Site Plan Review Committee (SPRC)  
Staff Report for  
**Air & Space Force Association (AFA) Site – 1501 Langston  
Boulevard (SP #366)**

## SITE PLAN REVIEW COMMITTEE

**Air & Space Force Association Site – 1501 Langston Boulevard**  
(RPC# 07-010-001, -002)  
Planning Commission and County Board meetings to be determined.  
*Krissy Walentisch (CPHD Staff)*

**SUMMARY:** The applicant, Taicoon Property Partners, proposes to demolish the existing office building and construct an 88-unit, eight-story residential condominium building with ground floor “institutional” space and 144 parking spaces located in the existing, to-remain underground parking garage.

Figure 11: Proposed Site Layout

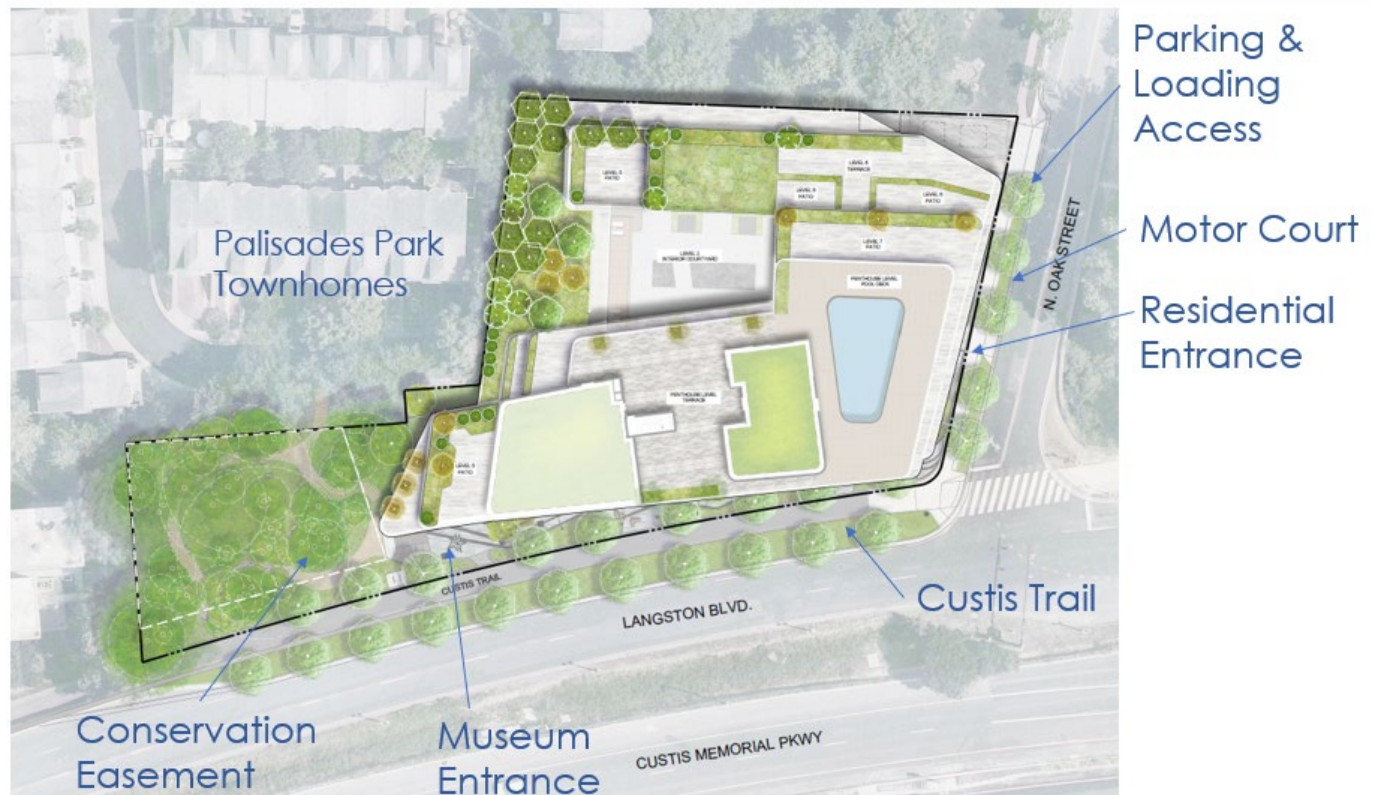
The applicant proposes a motor court, or porte-cochere, accessible from N. Oak Street. This driveway is intended for pickup and dropoff activities as well as deliveries and would divert congestion from N. Oak Street. However, this motor court creates an additional curb cut on N. Oak Street and is not typically a modern design or transportation solution utilized for residential buildings.

The Custis Trail runs along the north side of Langston Boulevard in this area and is currently hidden behind a tall sound barrier wall and the trail is narrow and dark. The Area Plan recommends that this portion of the trail be transformed significantly to become welcoming for pedestrians and bicyclists, which the applicant proposes to achieve by widening the trail and removing a portion of the sound barrier.

Figure 13: Building Section

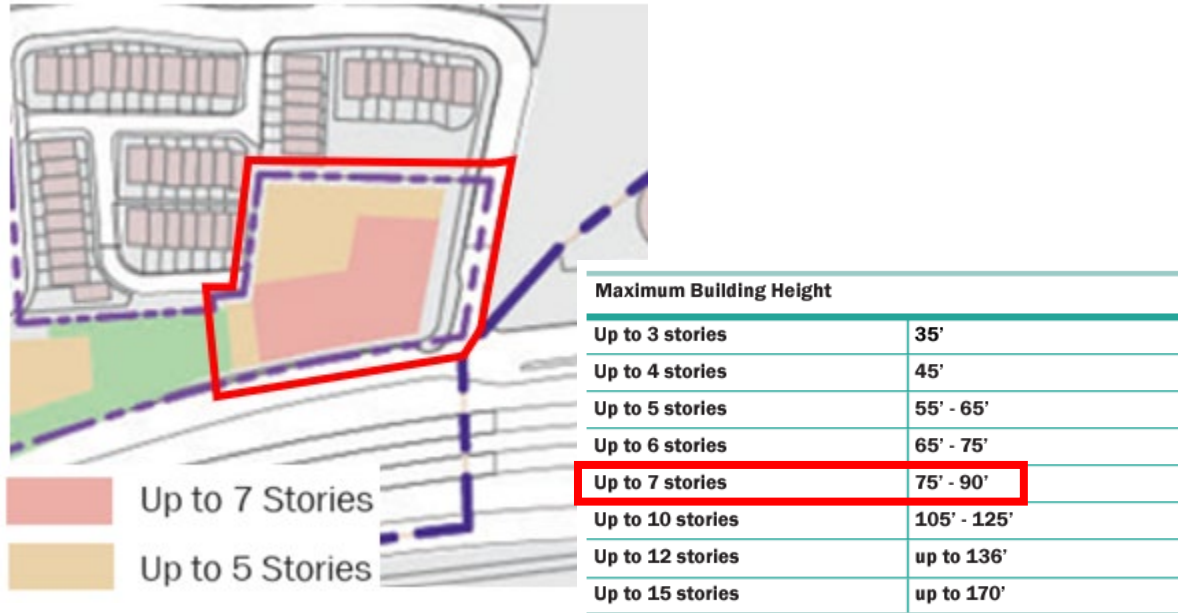
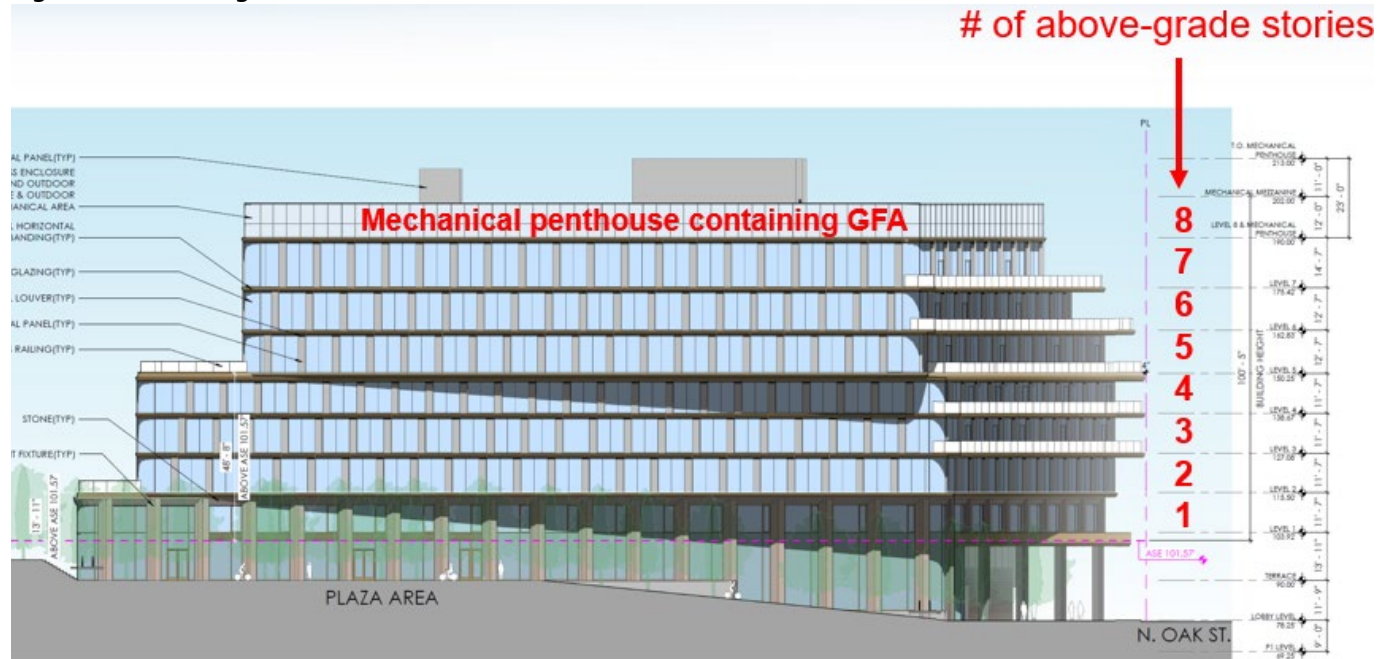
**Building Height, Form, and Architecture:** The Area Plan envisions that the building height be tapered in this location to provide a suitable transition to the townhomes and garden apartment buildings to the north and west. The Plan recommends a maximum building height of 7 stories along the Langston Boulevard and N. Oak Street frontages, which then steps down to 5 stories as it nears the adjacent townhomes. In staff’s review of the applicant’s plans, they appear to be showing occupiable space within their mechanical penthouse area shown in the elevation drawing below. Given that this level contains gross floor area associated with the residential use, this counts as an additional story, therefore making the overall building height 8 stories. However, if the applicant were to remove the GFA within the mechanical penthouse, the building massing and height would remain the same. We look forward to hearing your thoughts on the proposed building height.

- Proposed Height: 8 stories / 88 ft.
- LBAP Guidance: 7 stories / 90 ft.
- C-O-1.5 Zoning District: 10 stories

Figure 15: Area Plan's Recommended Massing & Proposed Massing Sections

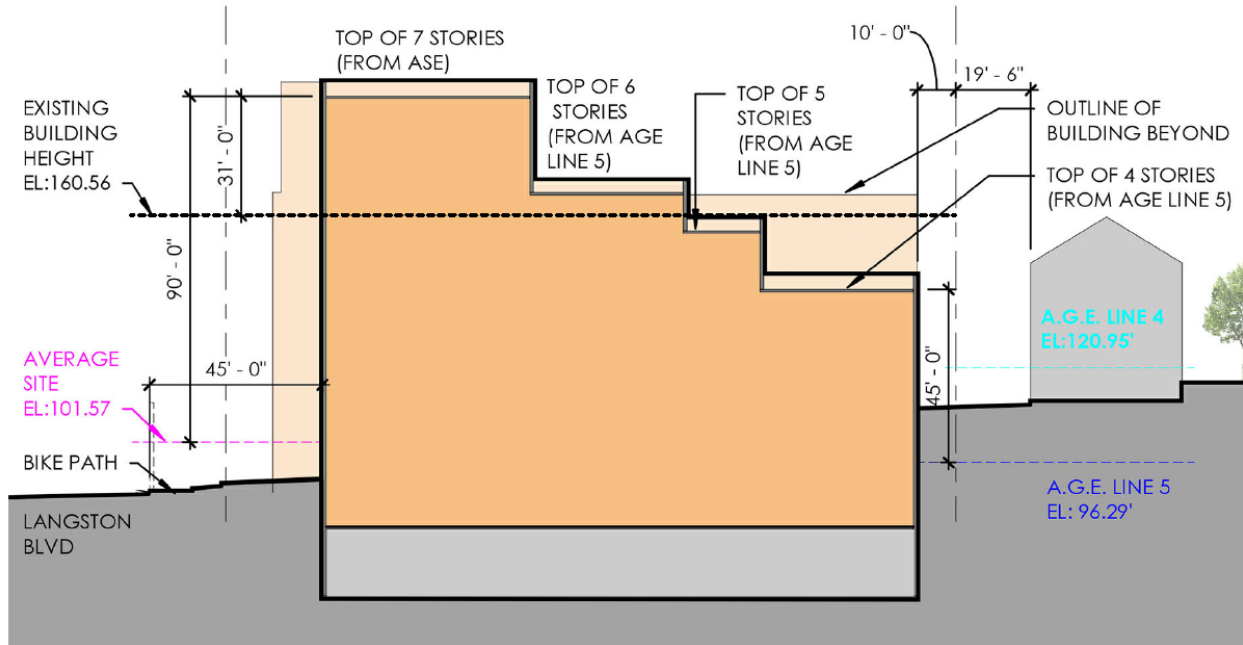
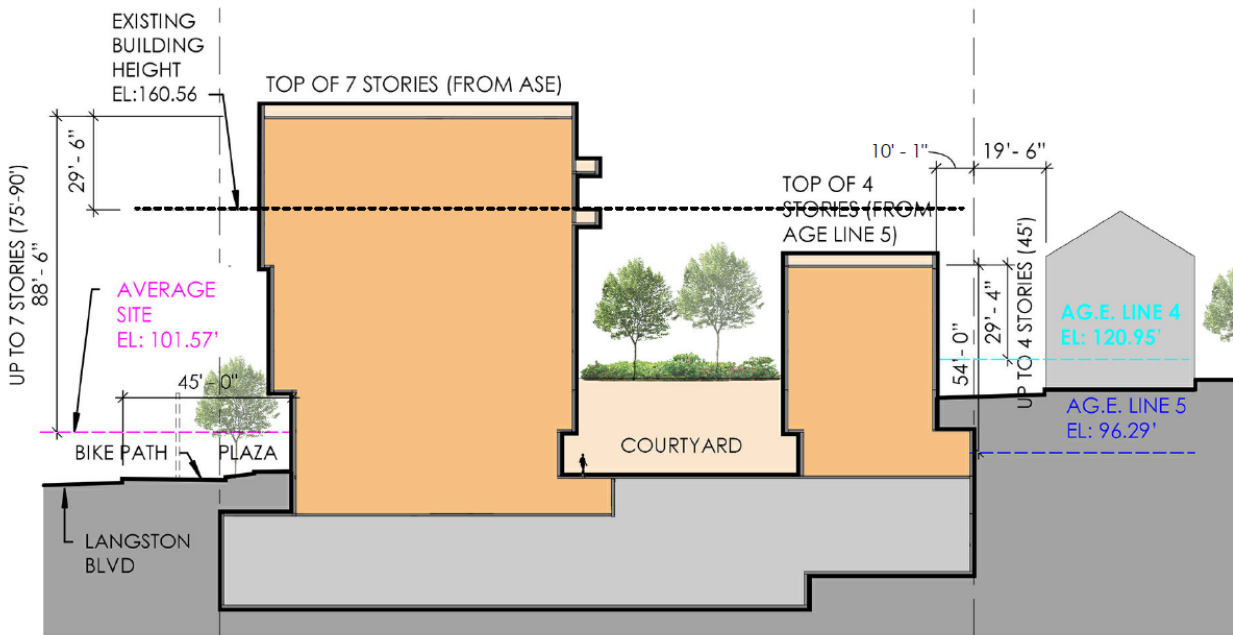
The Area Plan's Design Principles provide that building heights should be limited to four stories within 50 feet of the property line along the northern and western frontages, tapering up toward the seven-story volume to provide adequate neighborhood transitions. Seven stories (excluding the mechanical penthouse) are proposed along Langston Boulevard and N. Oak Street, and four and five stories are proposed along the Property's northern and western boundaries. The bulk of the building's massing is concentrated in the southeast corner of the property along N. Oak Street and Langston Boulevard, while the northern and western portions taper down near the Palisades Park neighborhood. The proposed building will incorporate a series of horizontal elements, such as balconies, to provide visual interest and differentiation in the massing of the building.

Figure 17: Site Access

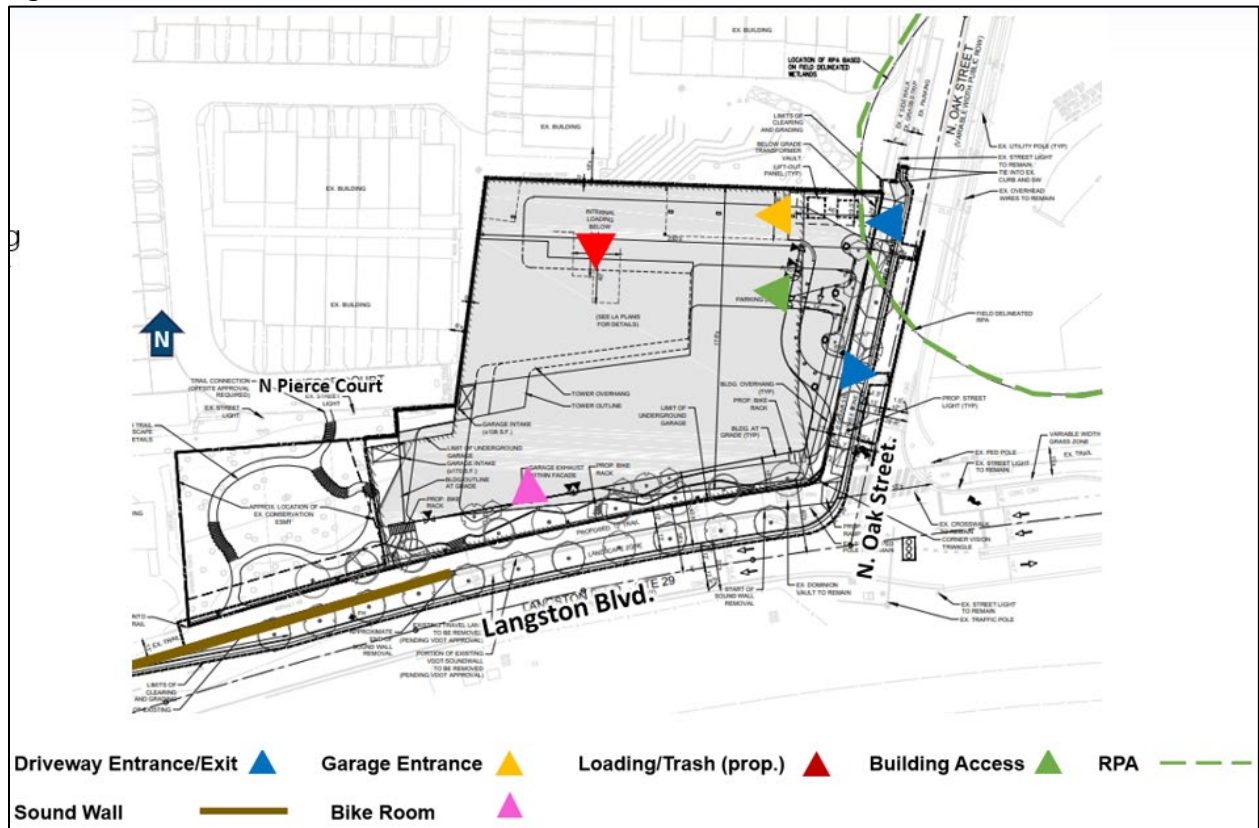
**Parking and Loading:** The LBAP recommends that parking and loading access be located on side streets rather than Langston Boulevard, located away from intersections, not visible from public spaces, and utilize screening to minimize visual and noise impacts. The Zoning Ordinance requires 1.125 spaces per multifamily unit and 1 space per 500 square feet (sf) of museum. The applicant proposes a total of 144 spaces in a three level below grade parking garage. The applicant proposes to reuse the foundation of the existing office parking garage. The applicant allocates the parking spaces as 141 spaces for residential/residential guest use at a ratio of 1.6 spaces per unit and 3 spaces for the museum use at a ratio of 1 space per 500 sf. The loading requirement is 1 loading space. The applicant proposes 2 loading spaces internal to the garage. Both the loading and parking are accessed from a shared entrance from North Oak Street.

Figure 18: Proposed Langston Boulevard Cross-Section (West)

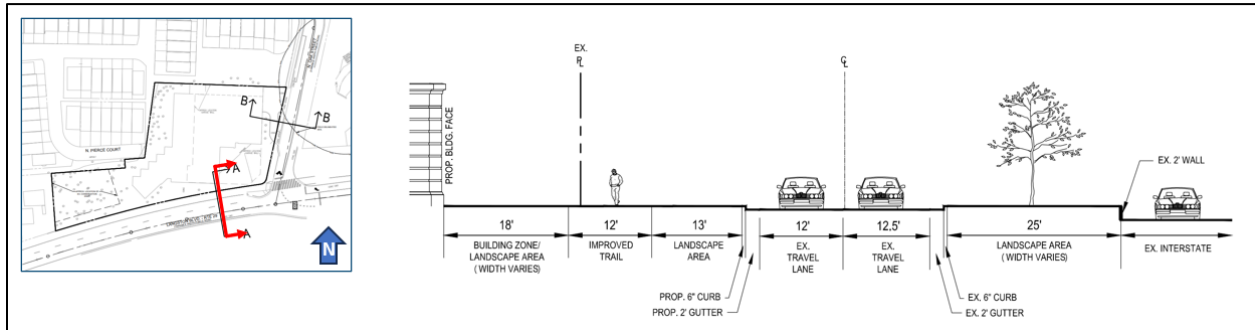
The applicant proposes to remove a travel lane along Langston Boulevard, reducing the number of travel lanes from 3 to 2, and to demolish a portion of the existing soundwall along the building frontage. The overall street width would be reduced to 28 feet. The Virginia Department of Transportation (VDOT) owns and maintains Langston Boulevard and will therefore need to approve any improvements affecting their right-of-way. As the existing soundwalls serve the nearby Interstate 66 any modifications to the sound wall will require approval from the Federal Highway Administration (FHWA).

The applicant proposes a 43-foot-wide streetscape consisting of a 13-foot-wide landscape area, a 12-foot-wide trail (Custis Trail), and an 18-foot-wide landscape area/building zone.

Figure 19: Proposed North Oak Street Cross-Section (Facing North)

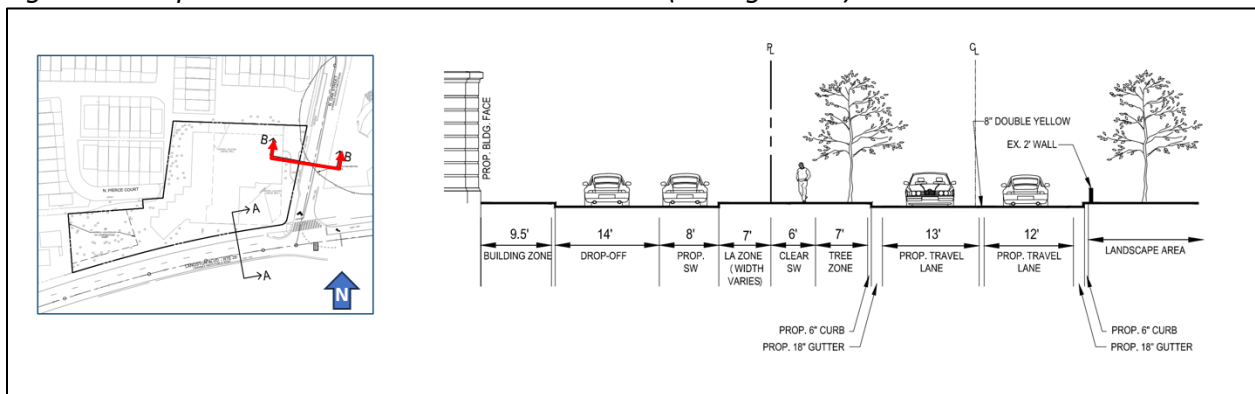
The applicant proposes to retain the existing two-lane configuration of North Oak Street. The overall width will be reduced to 28.6 feet. The southbound travel lane will be reduced from 20 feet to 13 feet and the northbound narrowed slightly.

The applicant proposes a 20-foot-wide streetscape measured from the overall face of the building (second story and above) to the curb. The proposed streetscape consists of a 7-foot-wide tree zone, 6-foot-wide clear sidewalk, and a 7-foot-wide landscape zone. A portion of the ground floor is recessed beneath the building for a covered motor court (or porte cochere). This area will consist of an 8-foot-wide parking lane, 14-foot-wide drive aisle, and a 9.5-foot-wide building zone.
